MARKED-UP TECHNICAL SPECIFICATIONS PAGES
(NUREG 1399)

Attachment 3 to TXX-92116
3/4 3-1 through 3/4 3-12

WPT-14385, "NOTIFICATION OF NONCONSERVATIVE
BORON DILUTION ANALYSIS INPUT ASSUMPTIONS"
FEBRUARY 12, 1992

TU ELECTRIC COMPANY
COMANCHE PEAK STEAM ELECTRIC STATION
UNIT NUMBER 1 & 2

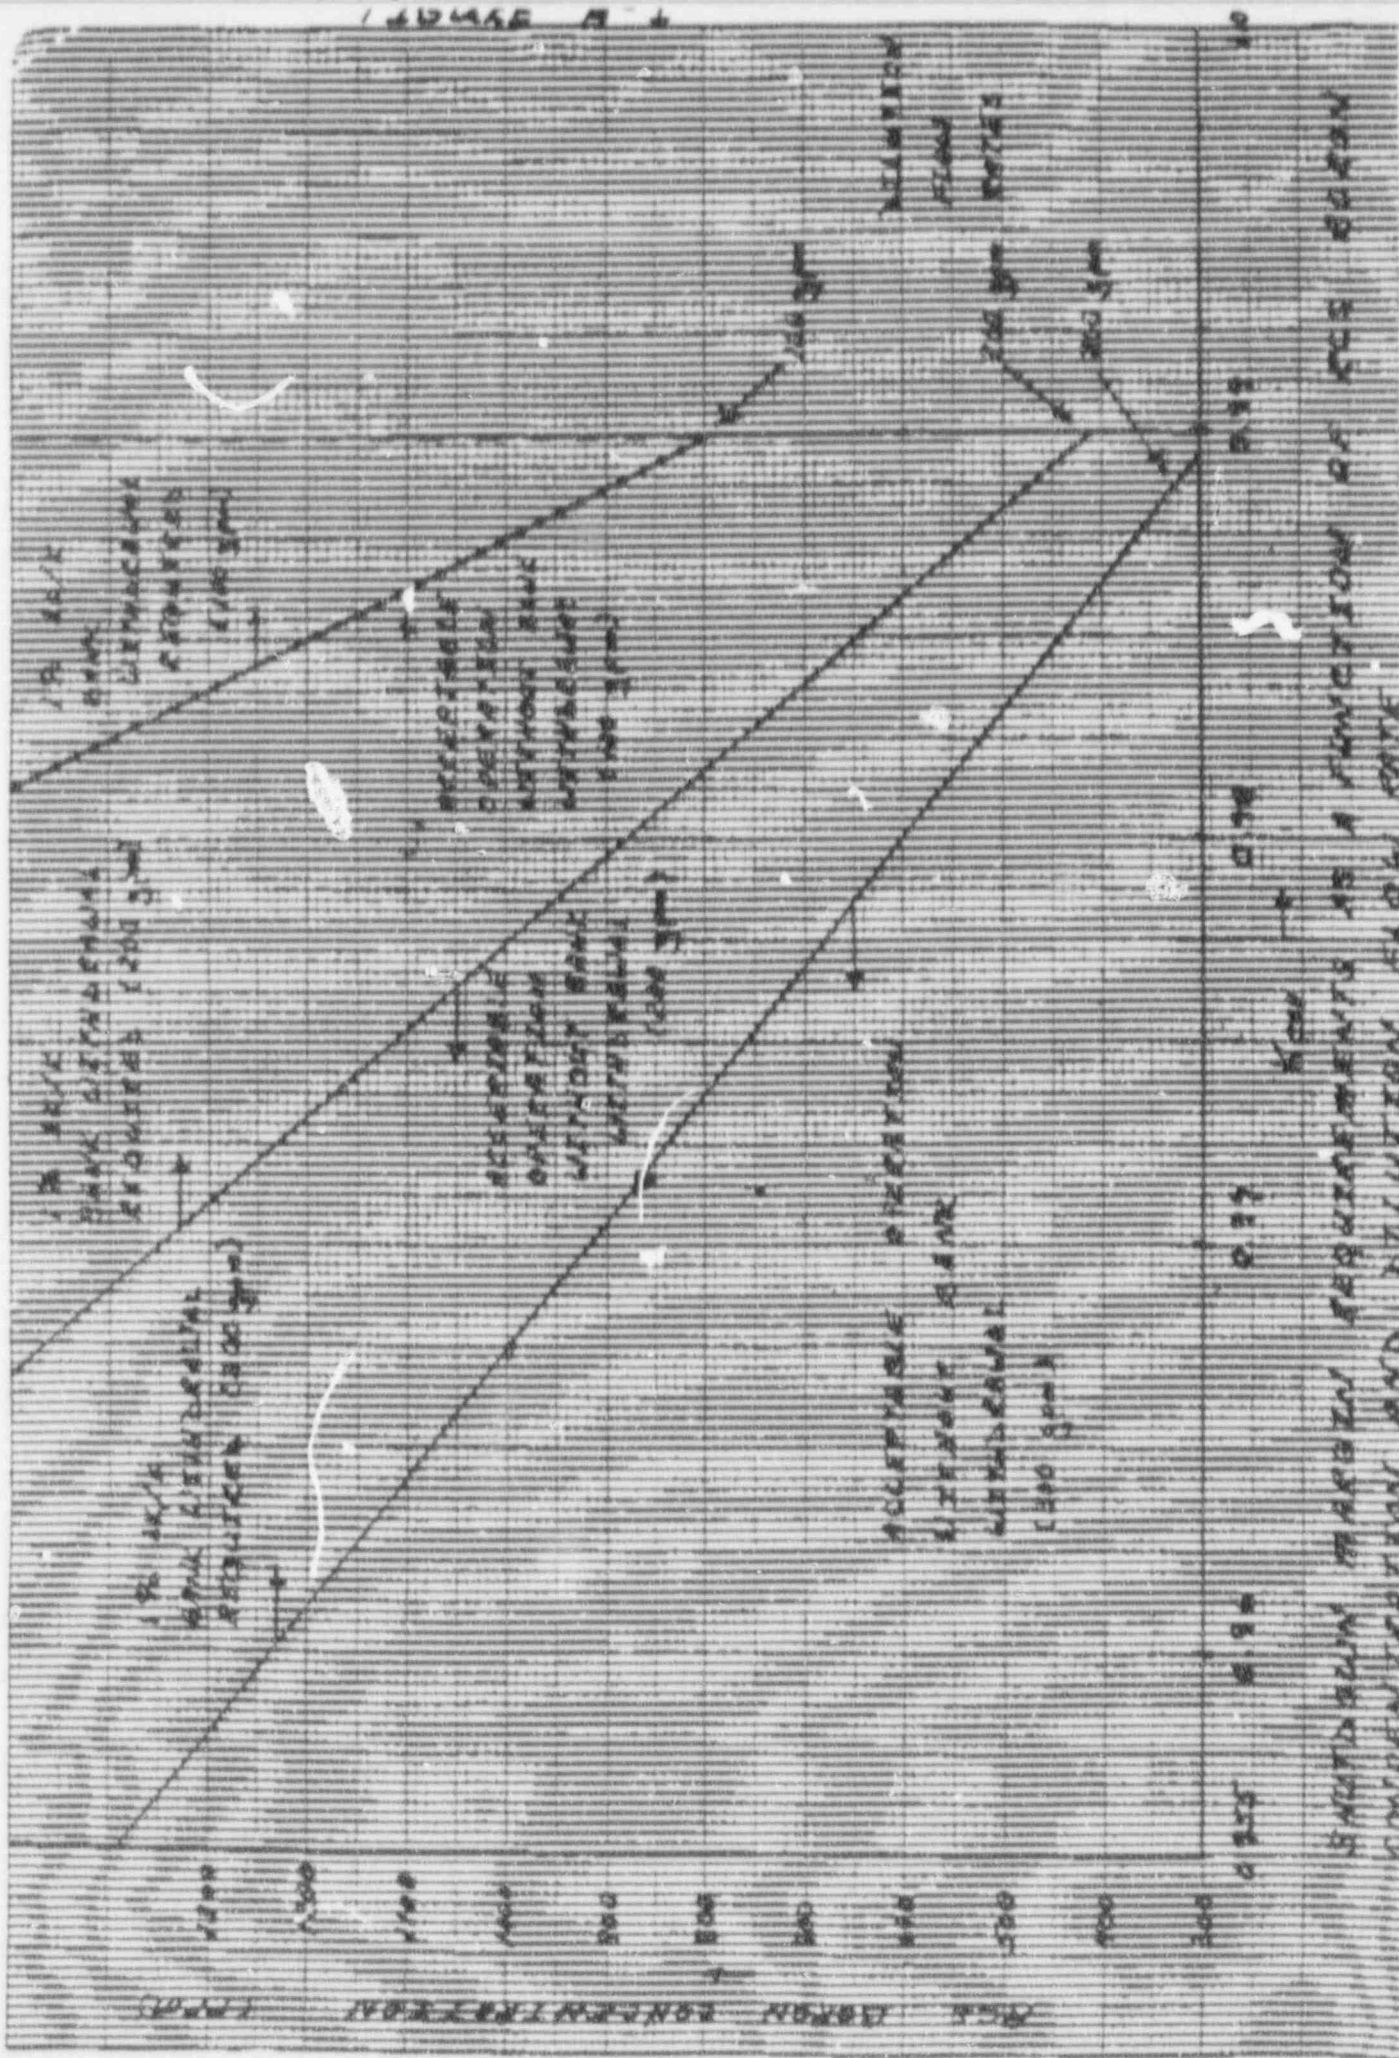
Figure A-1 notes areas of acceptable operation of three different dilution flow rates as a function of RCS boron concentration and borated shutdown margin (K_{eff}). For a given dilution flow rate, if the RCS boron concentration and shutdown margin result in a point placed to the left of the flow rate line, no control rod bank withdrawal is necessary. If the results place the plant to the right of the line, then either the shutdown margin must be increased such that the plant is moved to the area of acceptable operation, or 1% $\Delta k/k$ in control rods must be withdrawn to provide additional shutdown margin. The tripping of the withdrawn rods provides positive operator indication that a dilution event is in progress and additional time for operator termination of the event. In all cases, a shutdown margin of 5% $\Delta k/k$ ($K_{eff} < 0.95$) is considered sufficient for continued operation without a requirement for control rod bank withdrawal.

Figure A-1 is based on best estimate calculations for the "all rods in" configuration. It is recommended that the Westinghouse Nuclear Design Report for your plant be used as a reference in determining the RCS boron concentration with the appropriate conservatism to be used in the figure. The Westinghouse Nuclear Fuel Division is available to provide assistance in meeting the constraints imposed by the Figure A-1 requirements.

Use of Figure A-1 is applicable any time there is boration/dilution capability from the normal boric acid blending system. The above procedure is not required if boration and/or makeup during cold and hot shutdown is performed utilizing water from the RWST. This requires that the normal dilution/boration path is isolated from the charging path. Two means of lockout to isolate the charging path are available:

1. Lock out Reactor Makeup Water Supply.

This is accomplished by valve 8338 for 212 plants, valve 8457 for 312 plants, and valve 8455 for 412 plants.

2. Lock out valves between the boric acid blender and the VCT.

These are FCV-111B, FCV-110B, 8339, 8355, and 8361 for 212 plants; FCV-114A, FCV-113B, 8454, 8441, and 8439 for 312 plants; FCV-111B, FCV-110B, 8453, 8441, 8439 for 412 plants.
